**REDINGTON FROGNAL ASSOCIATION**  
Umbrella body for residents groups in the Redington Frognal Conservation Area

**Planning application 2019/1908/P: 59 Redington Road**

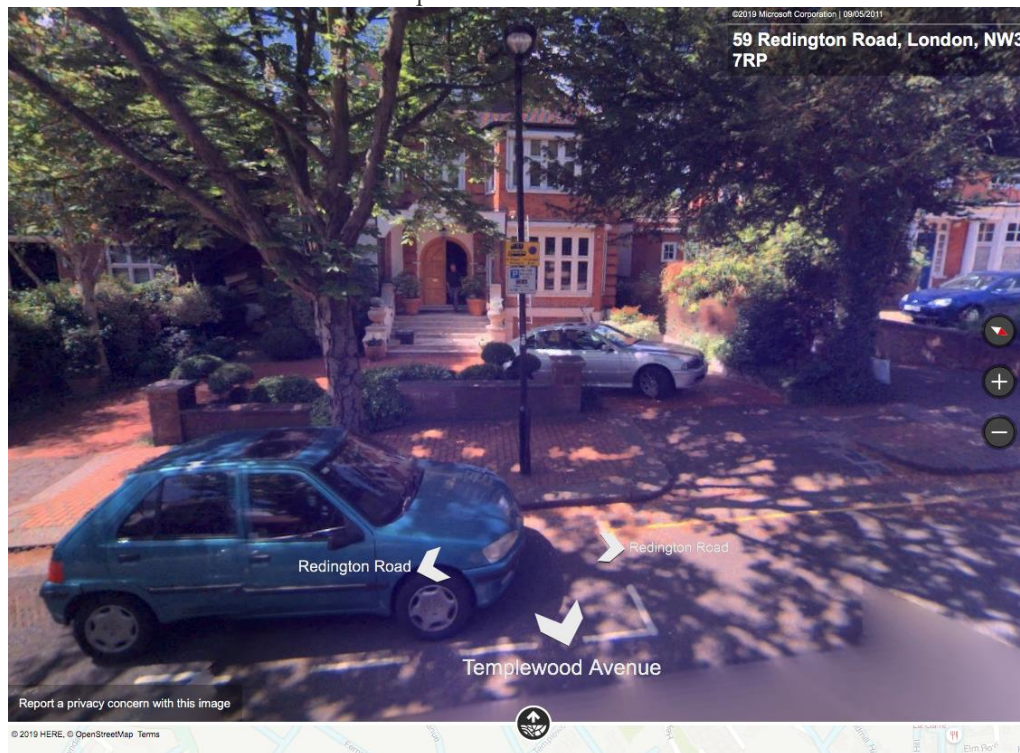
The photo below shows the low boundary wall, with planting behind, which is a typical Redington Frognal boundary treatment. Its replacement by metal gates would cause considerable harm to the streetscape.
